# Product Upgrade Bulletin 170906REV

**UPGRADE  
BULLETIN:  
170906REV**

Inspection/  
Correction  
of Mounting  
Hardware on  
Power Gear  
Leveling Jacks

December 2017

Figure 4

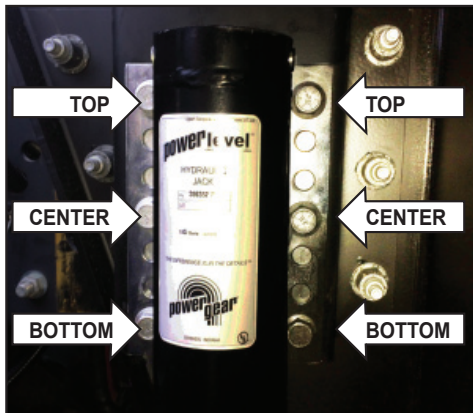
6. If the inspection determines the need for replacement of the jack fastening hardware, follow the steps as outlined below. Refer to Figures 4 and 5. **Jacks are not to be removed.**

- a. Remove the bottom mounting bolt from one of the jacks.
- b. Working upward on the same side, remove the center bolt.
- c. Remove the top bolt last.

Reverse the order when installing the new bolts and nuts. See Figures 4 & 5.

- d. Install the top bolt first.
- e. Install the center bolt next.
- f. Install the bottom bolt last.
- g. **Torque bolts to 108-120 ft-lbs.**
